## Keyer I/F & AK4951 v2.0.1 PCB Errata

17th Aug, 2017  
ji1udd

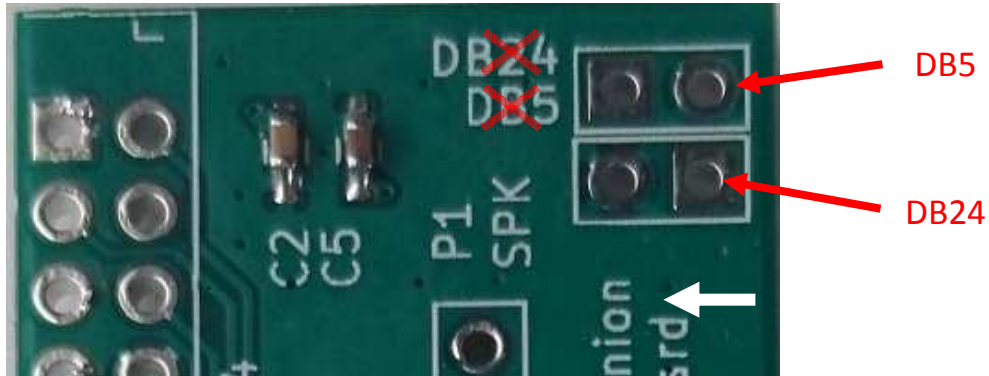
### 1) Wrong Silk

The silks of DB5 and DB24 are swapped

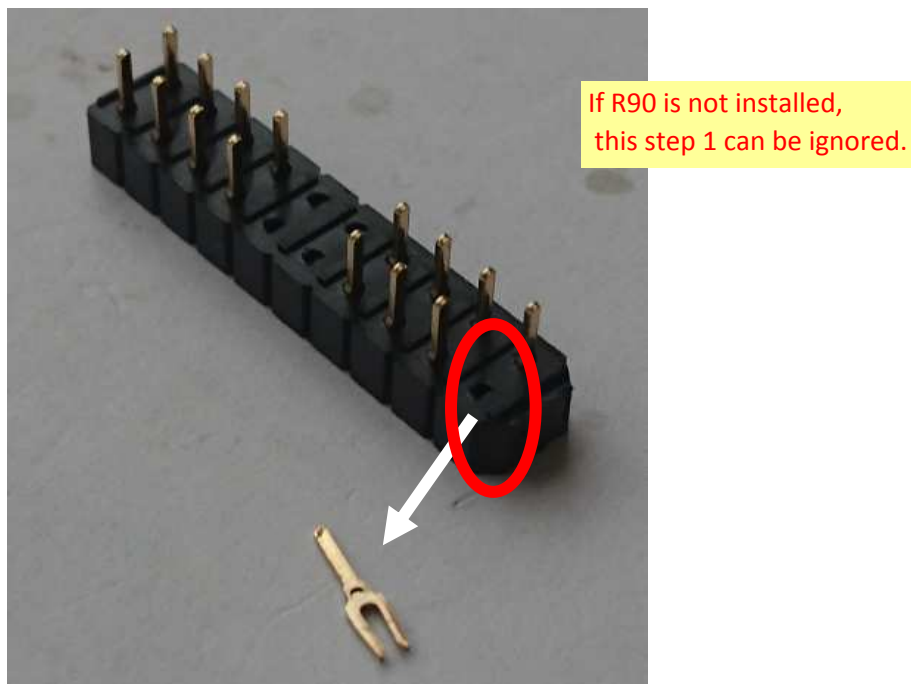
### 2) Wrong FPGA signal assignment

FPGA Pin89 (CN5-7) cannot be assigned as Output port.

#### Counter measure

FPGA Pin76 (DB24-1) is connected to AK4951 Pin11(SDTI) instead.

Step1. Pull CN5-7 contact pin out.

Step2. connect DB24-1 with CN5-7
